TITLE: UD700 **Copyright** 2017 GHI Electronics

Document Number: **REV:** A

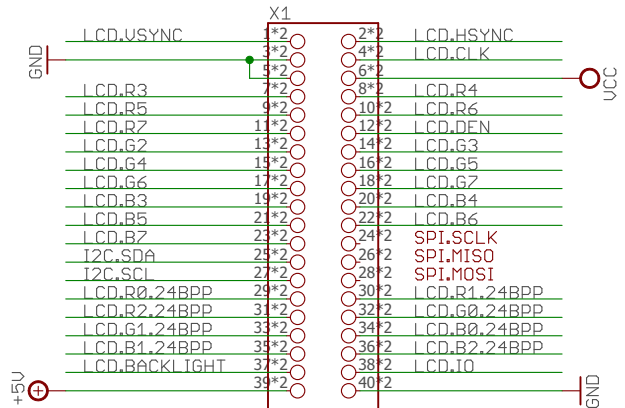
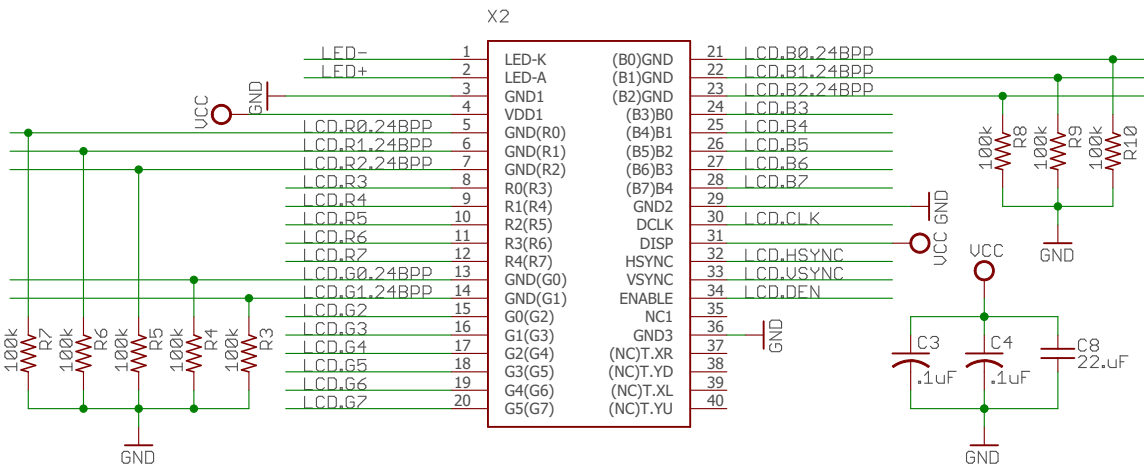
D3 (the zener diode) is not needed across the LED+ and LED- nodes as it will needlessly cause the LED Driver to heat-up forcing the voltage to stay at 33V without a load. For the FAN5333 driver (315mV FB), change R2 to 7.87 Ohms for 40mA (7 in display) For the PT4110 driver (300mV FB), change R2 to 7.5 Ohms for 40mA (7 in display)
